Urban Bushland Council WA Inc.
PO Box 326
West Perth WA 6872

Appeal – EPA Report 1471

Mangles Bay Marina-Based Tourist Precinct

EPA Report, Figure 2.

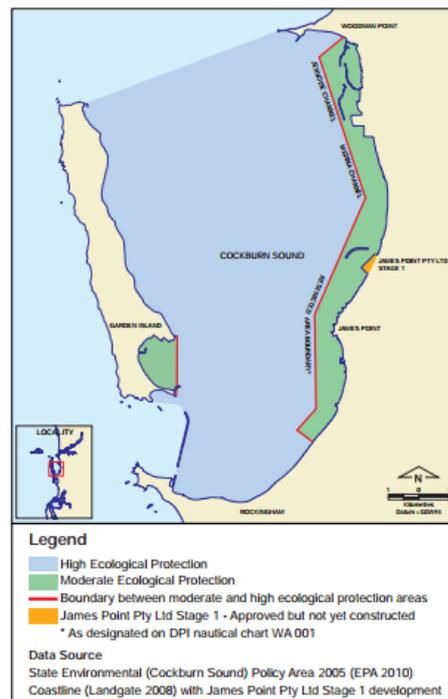
Appeal Ground 6: Figure 2 EPA Report. Figure lacks adequate key.

Concern: Figure 2 does not accurately depict the extent of the High Ecological Protection Area, part of the causeway is the same colour as the water. The State Environmental (Cockburn Sound) Policy Area EPA 2005 shows the High Ecological Protection Area a separate colour which is easier to identify. Incomplete figures make it difficult to assess and interpret the data presented.

Outcome Sought 6: The EPA Chairman request a revised Figure 2 which clearly depicts the High Ecological Protection Area.

Above: PER Part I, Figure 18 (does not match data in Annual Report).

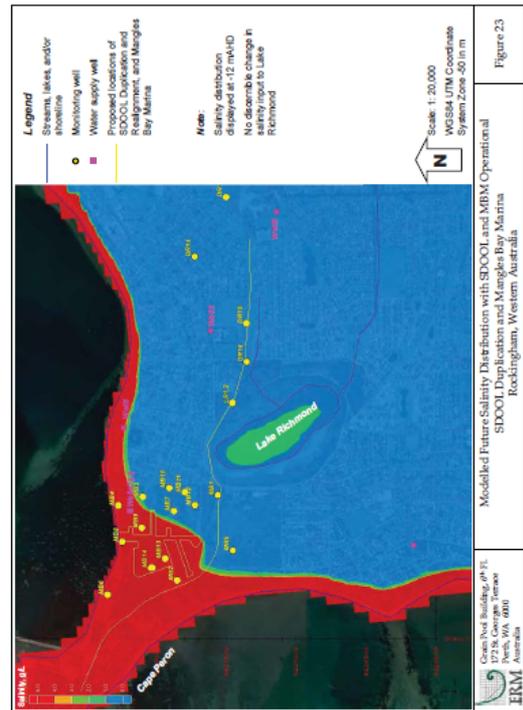
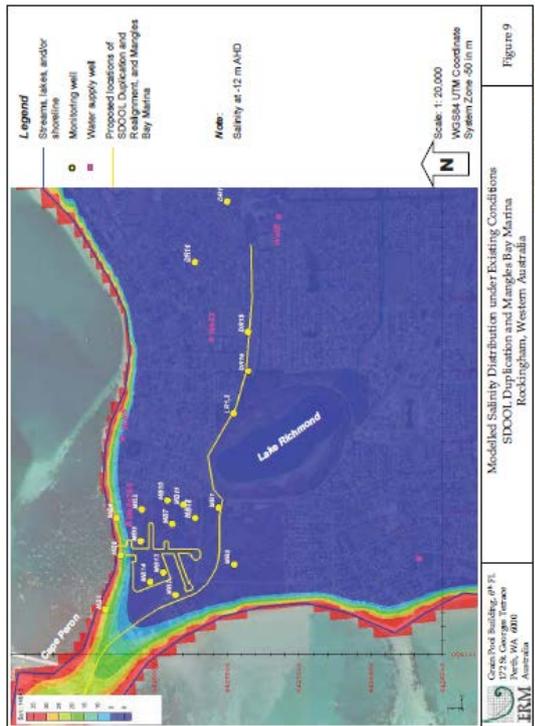
The first two figures reproduced below show the modelled salinity at -12 m during current conditions and during operation of the marina. The two figures are dominated by blue indicating an EC of <1,000.

Above: modelled salinity under existing conditions (left) and duplication of SDOOL (right), at -12 m. (Data does not match that shown in Annual Report).

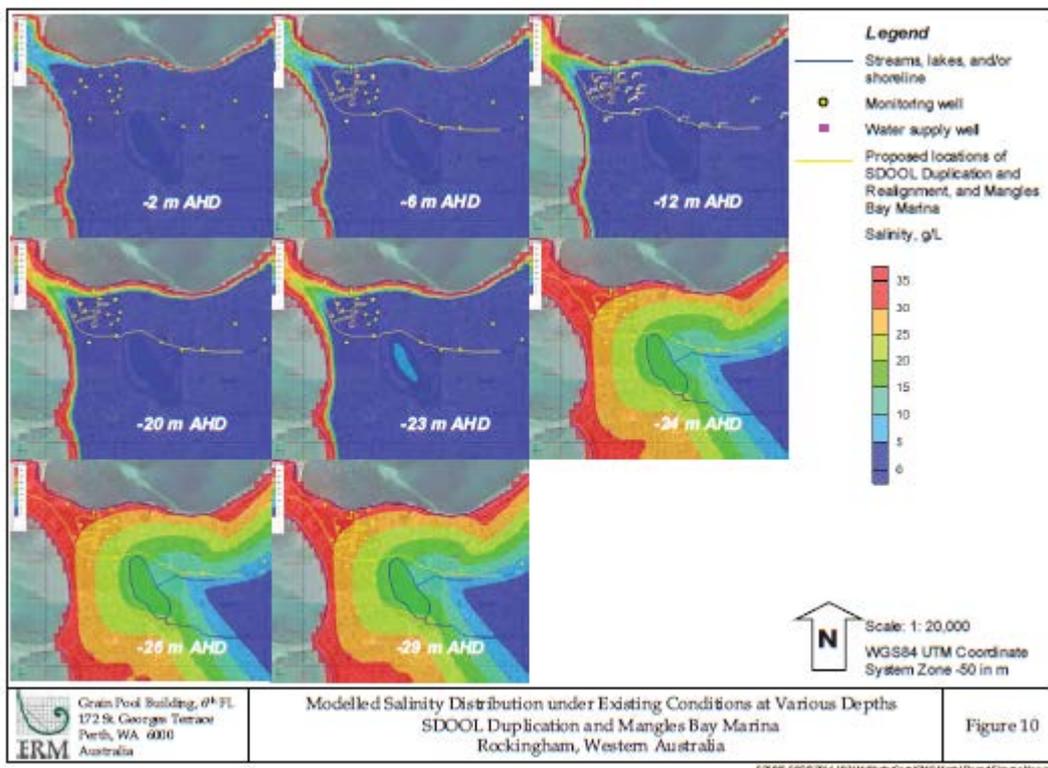
The erroneous salinity figures are further abused when modelling the current salinity for the SDOOL relocation. Salinity at -12 m again is depicted as being very low (key hard to read), which does not reflect reality as described in the Annual Report.

This Figure is misleading as it states it is showing "Existing Conditions" but these conditions do not match the salinity results in the Annual Report. Salinity levels measured from the monitoring bores

in March 2011 shows a distinct increase in salinity at a depth of 20 m. This Figure shows the high salinity layer occurring at a depth of 24 m. It is assumed that this is an average level, although there is no date on the Figure. Figure 11 (below) is a cross-sectional view and shows the “Average salt water interface during monitoring” at 24 m, although again there are no dates on the Figure.

Above: Modelled ground water salinity (existing conditions, no date). Does not match salinity levels in Annual Report.

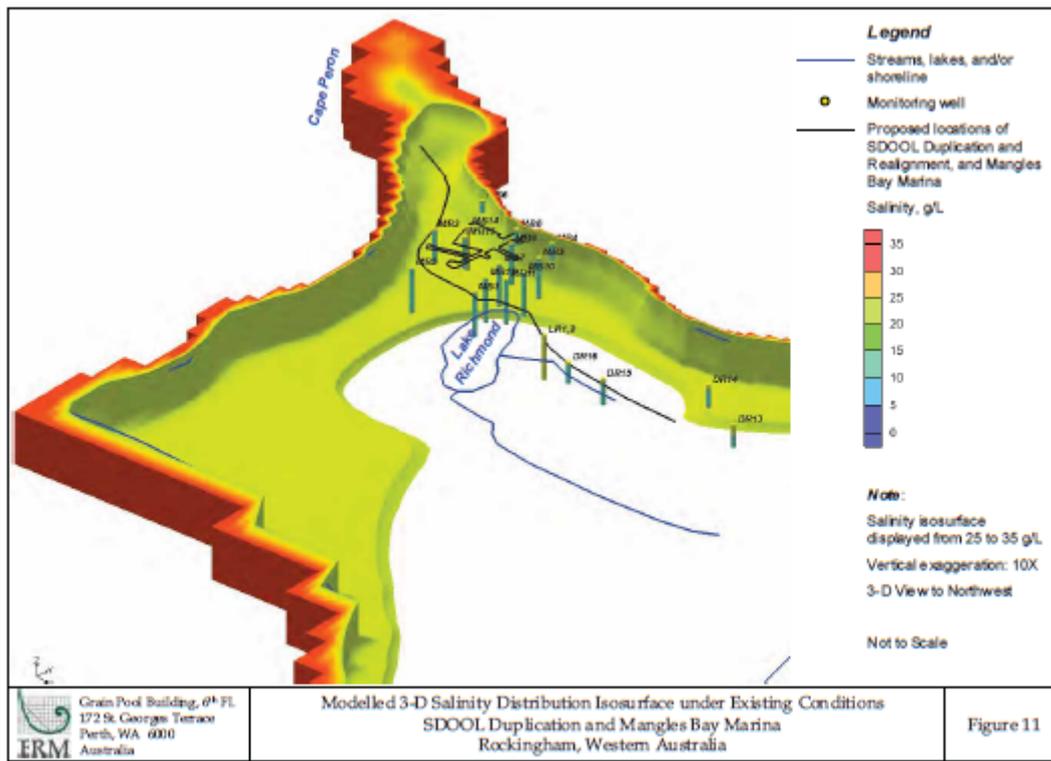
The ground water monitoring was undertaken during a very dry period with ground water levels lower than expected in an average year. This qualification should be included on the graphs together with the dates of the monitoring program from which the averages were derived. An “average” from a dry year is very different to a “long-term average”. From PER Part i:

Above: Dashed lines show the proponents modelled movement of the sea water wedge and the unknown effect on ground water salinity located above the wedge (shown as orange and yellow).

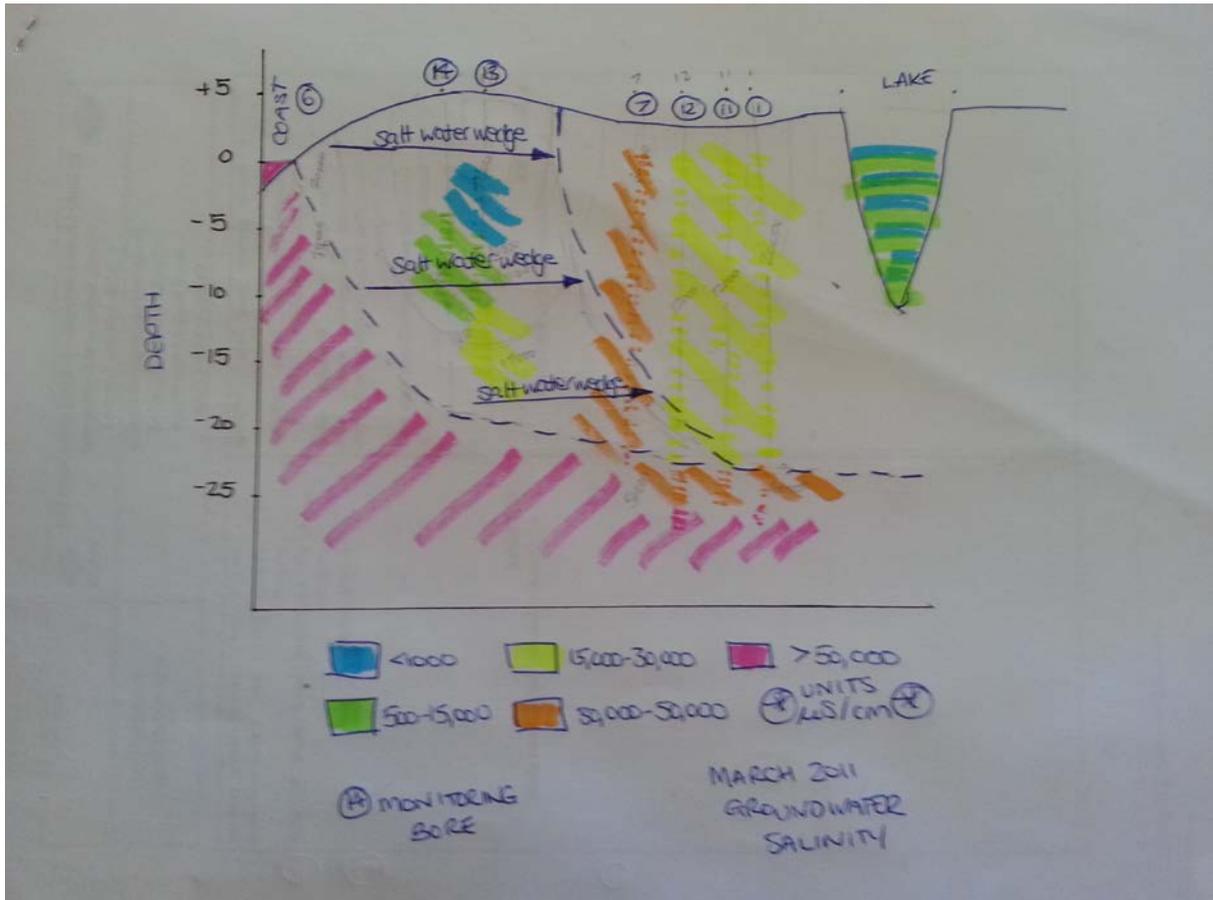
The figure below shows the modelled movement of the sea water wedge and the unknown effect on the saline water upslope (shown as orange and yellow). Intrusion of the dense sea water will of course displace the saline water in the soil water pores between the wedge and the lake. What is the nature of this displacement? Will the saline water be displaced upslope towards Lake Richmond increasing the salinity in the freshwater lake and impacting upon the two Endangered communities located there?

Outcome Sought 16b: The EPA Chairman to request modelling of the movement of brackish water towards Lake Richmond (above the sea water wedge) to assess the impact of groundwater quality on the TEC of Lake Richmond Thrombolites, including the effects of changes in EC, pH, calcium, bicarbonate and carbonate.

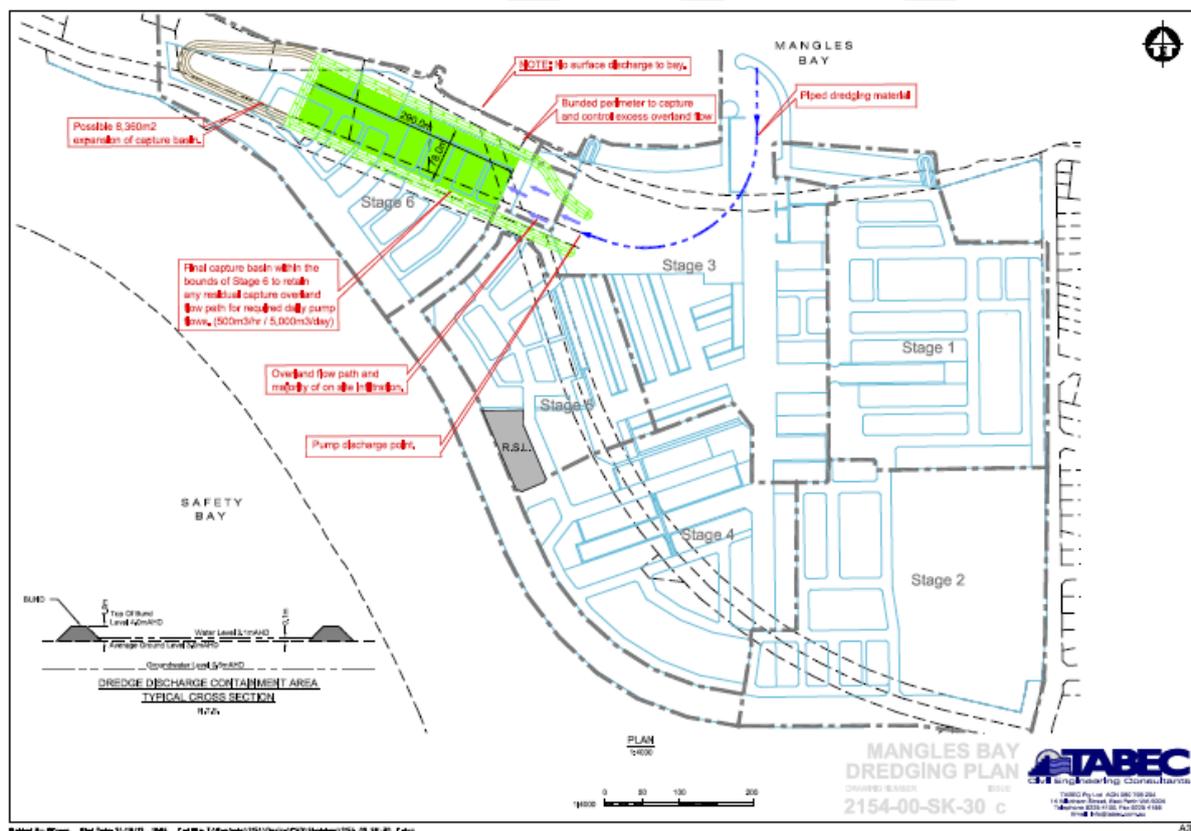
EPA Condition 6-1 During Marine-Related Construction Activities the proponent shall implement measures to ensure that there is no discharge of dredge return water to the waters of Mangles Bay, including from the piping of dredge spoil direct to land-based settlement basins.

Should the underlined phrase be “decant water” or “dewatering”? If it is actually referring to “return water”, where will the water be returning to?
